**Economic and Social Council**Distr.: General
21 October 2016

Economic Commission for Europe**Inland Transport Committee****World Forum for Harmonization of Vehicle Regulations****Working Party on Passive Safety****Sixtieth session**

Regulation No. 16 (Safety-belts)**Proposal for Supplement 1 to the 07 series of Amendments to Regulation No. 16 (Safety-belts)****Submitted by the expert from France***

The text reproduced below was prepared by the expert from France, on behalf of the informal group on Child Restraints Systems, updating the latest versions of Regulation No. 16. The modifications to the current text of the UN Regulation are marked in bold for new or strikethrough for deleted characters.

Figure 2

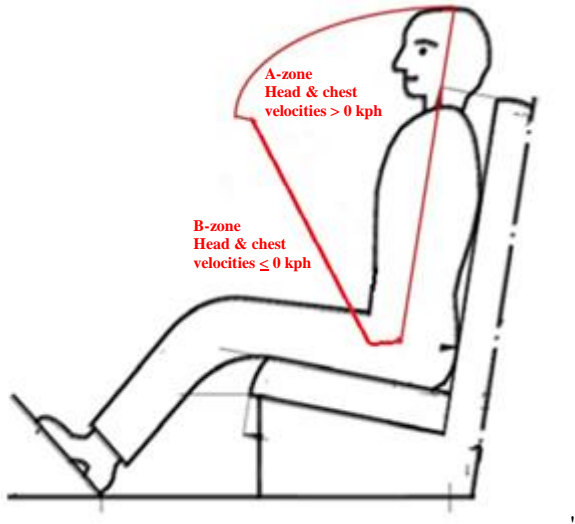
"12.1. In case a restraint system has been granted/extended, those can be used for particular types of vehicles compatible with the following dimensional conditions: no interior part in a quoted A-zone as shown below (Figure 2):

"Figure 1
Specifications of the fixture (all dimensions in mm)

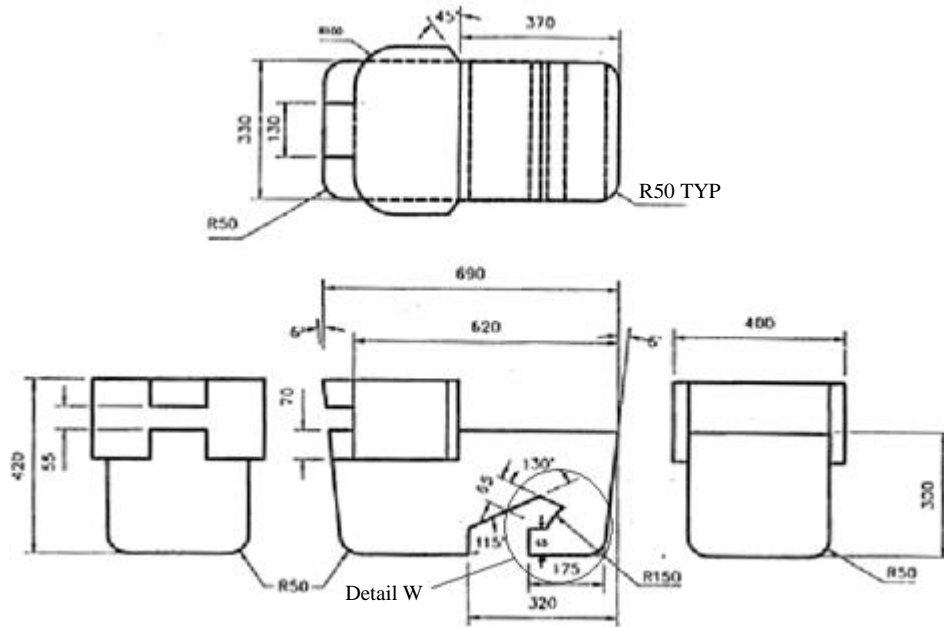
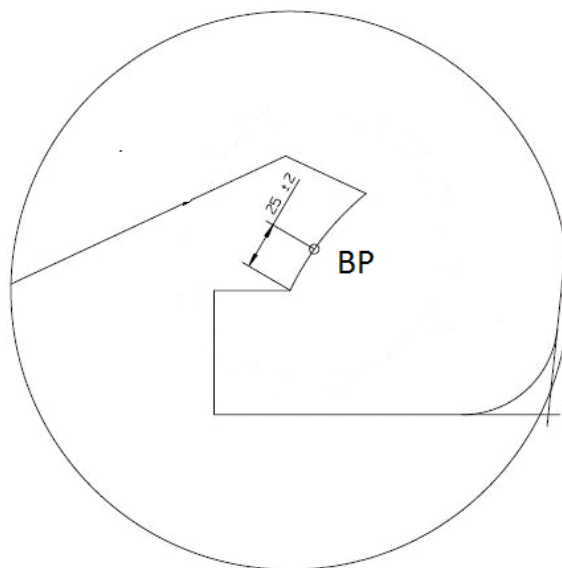
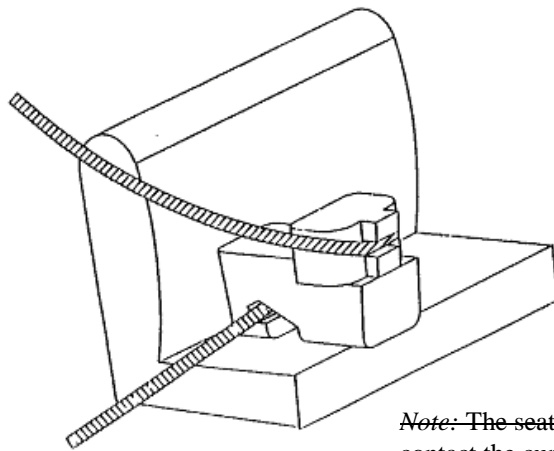
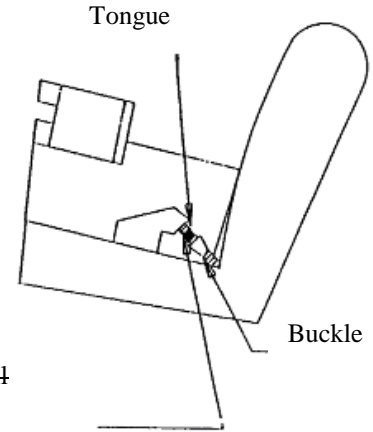
- "3.2. The lap portion of the belt shall touch the fixture on both sides at the rear of the lap belt path (see Figure 3). **The seat belt webbing shall always cover the points BP on the left and right ends of the curved edge; the exact position of point BP on the curved edge is indicated in detail W of Figure 1.**

Figures 1 to 3, amend to read:

Note: The seat belt webbing shall contact the curved edge on both sides of the fixture

Figure 7
Reduced-Size Rearward Facing toddler CRS Envelope dimensions for a reduced-size rearward-facing CRS, modified for improved compatibility with the vehicle interior

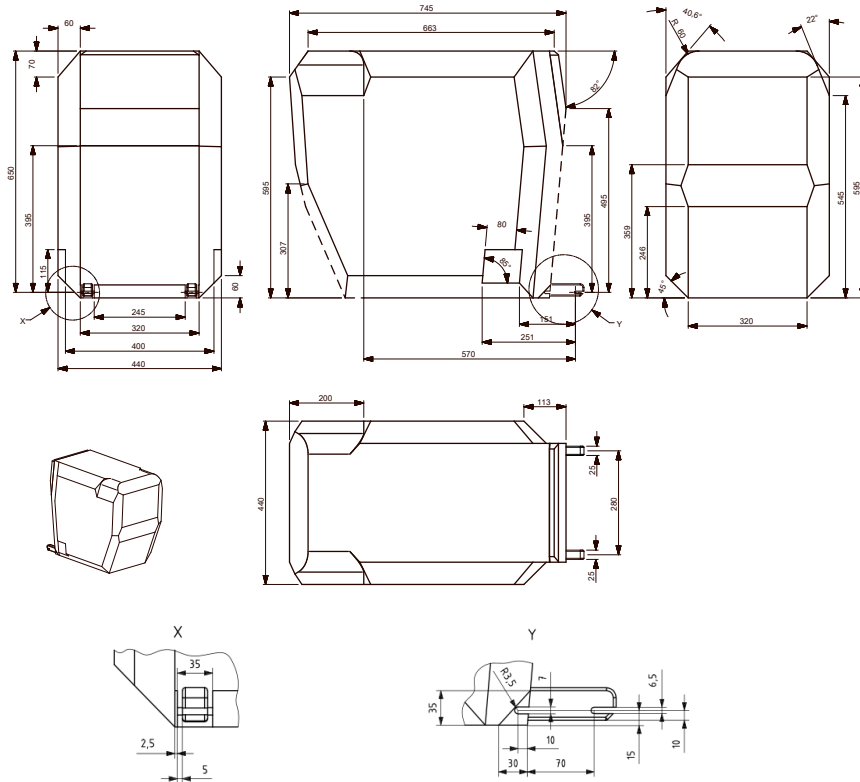
Annex 17, Appendix 2, insert new paragraph 4.7. and new Figure 7 to read:

"4.7. Rearward facing infant child restraint systems envelope ISO/R2X

- 1 limits in the rearward and upward directions
- 2 dashed lines mark the area where an anti-rotation device, or similar (e.g. rebound bar), is allowed to protrude
- [3 the backward limitation (to the right in the figure) is given by the forward-facing envelope in Figure 2]
- 4 further specifications of the connector area, see detail Y and ISO 13216-1:1999, Figures 2 and 3."

Figure 7.8
 Envelope dimensions for lateral facing position CRS - ISO/L1- ~~ISOFIX SIZE CLASS F~~ or symmetrically opposite - ISO/L2 (figure shown) ~~ISOFIX CLASS G~~

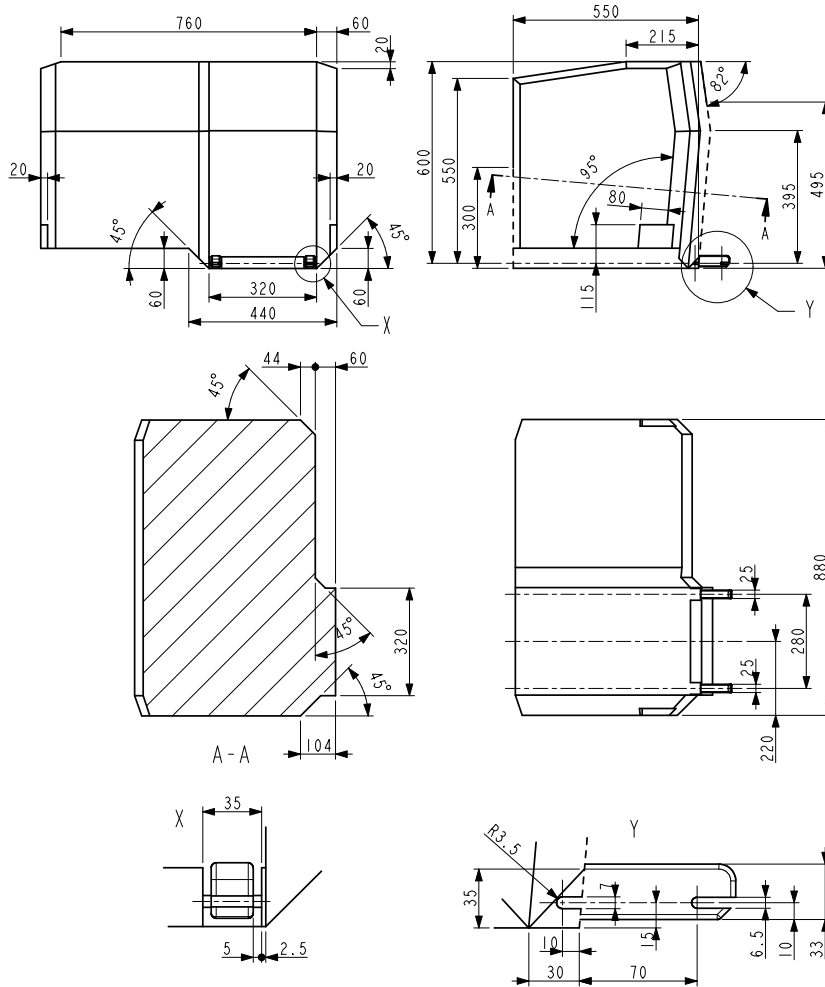
Annex 17, Appendix 2, paragraph 4.7 (former), renumber as paragraph 4.8. and amend to read:

"4.7.8. Lateral facing child restraint systems envelope

Note: The envelope for a left lateral-facing infant CRS (ISO/L1) has dimensions symmetric to ISO/L2 with regard to its intermediate longitudinal plan.

- 1** limits in the rearward and upward directions
- 2** dashed lines mark the area where an anti-rotation device, or similar (e.g. rebound bar), is allowed to protrude."

Figure 1
Positioning in Seat

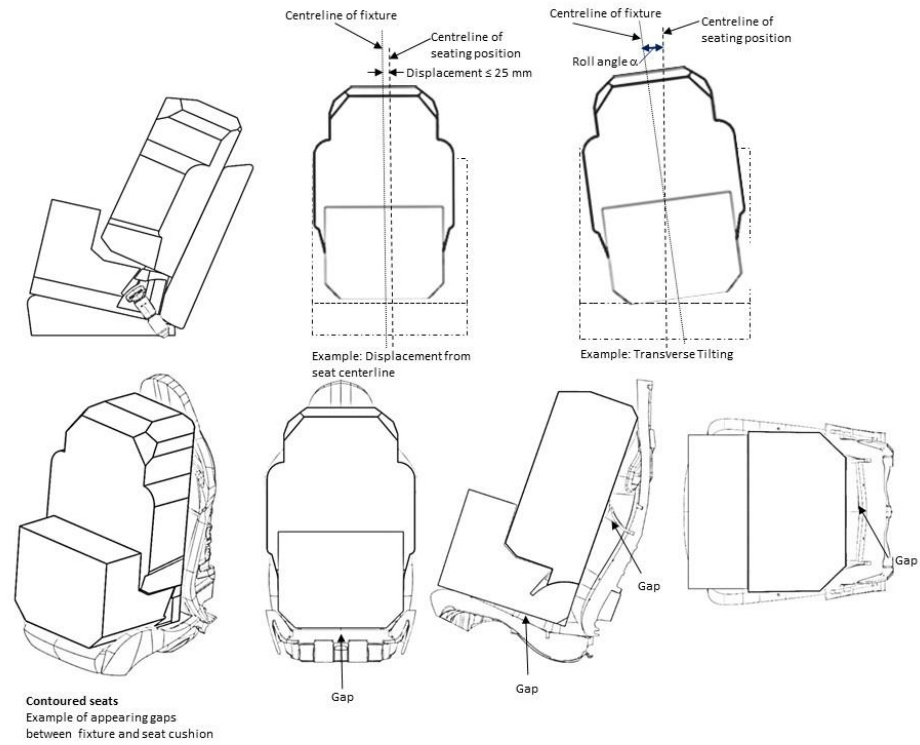
Annex 17, insert new Appendix 5 to read:

- 3.1. It shall be possible to secure the fixture in the seating position using the 3-point seat belt and to buckle up the seat belt.
- 3.2. The roll angle α as shown in Figure 1 shall be equal to or less than 5° .

- 3.3. The base of the fixture shall be in contact with the seat cushion, and the back face of the fixture shall be in contact with the seat back or head restraint. Full contact with the seat is not necessary, “gaps” due to the vehicle seats contours are permitted as shown by the arrows in Figure 1. The booster seat envelope is equipped with an adjustable backrest. Compatibility with the vehicle seating position shall be achieved in at least one position of the backrest range shown in Figure 2 or Figure 3.

Figure 2
ISO/B2: Envelope dimensions for booster seat, reduced width 440 mm - without ISOFIX, or with connectors removed or stowed within the body of the fixture (behind line E, as defined by detail B).

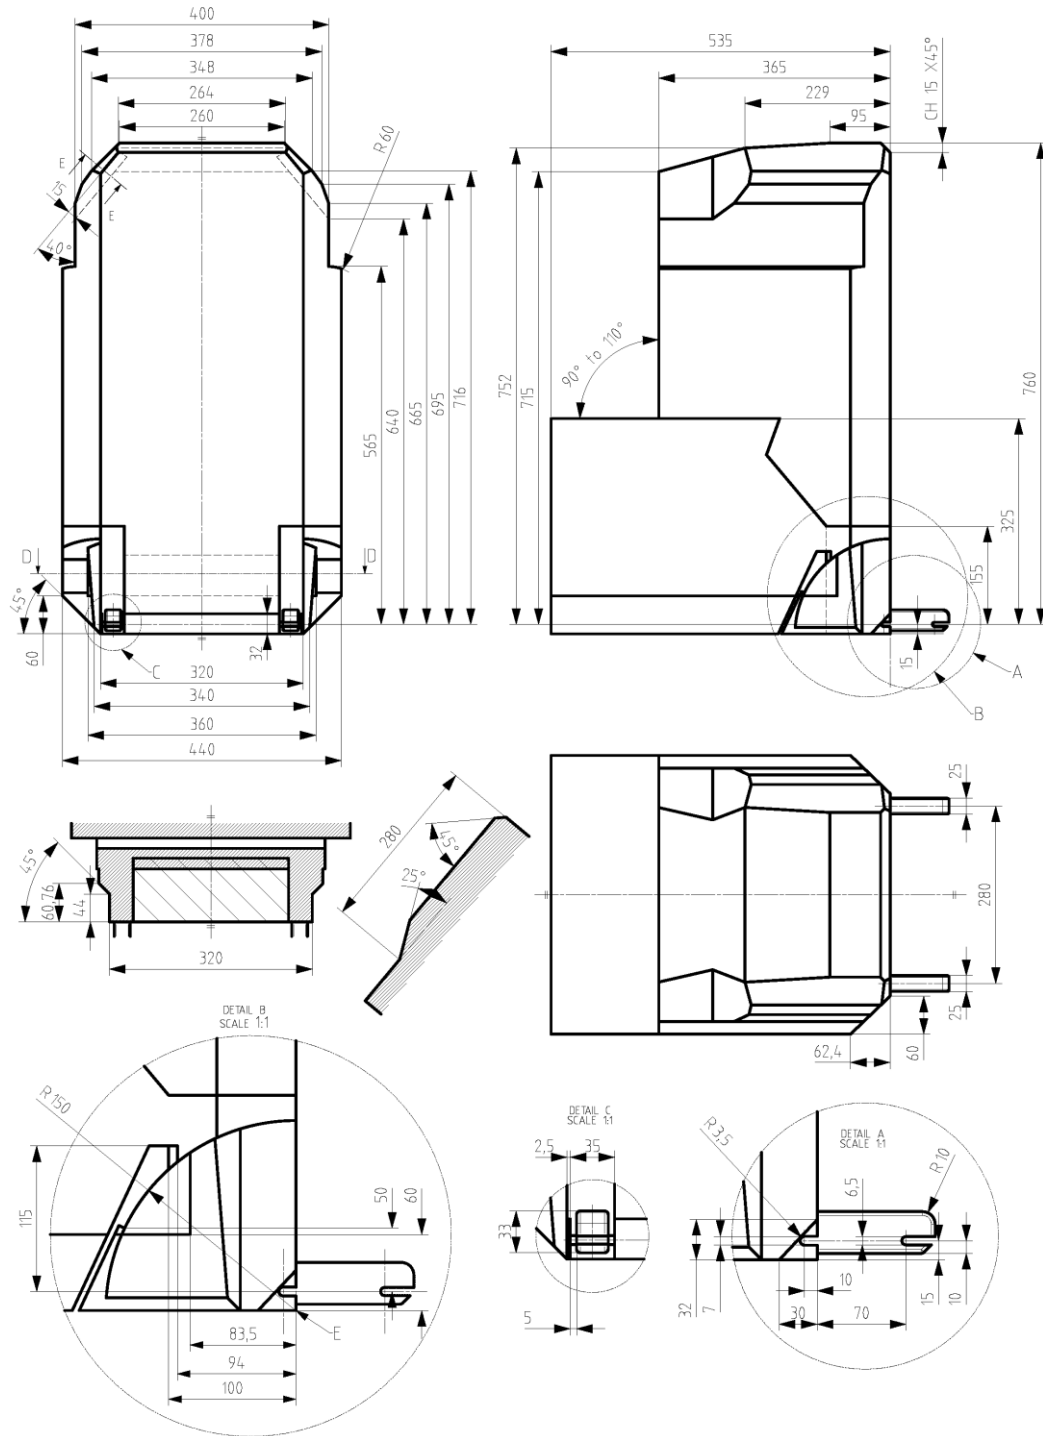
- ISO/B2: Booster seat, reduced width 440 mm (figure 2)
- ISO/B3: booster seat, full width 520 mm (figure 3)

Key **E** is the Reference axle of rotation of the backrest (90° to 110°) and reference line for retraction/stowing of ISOFIX
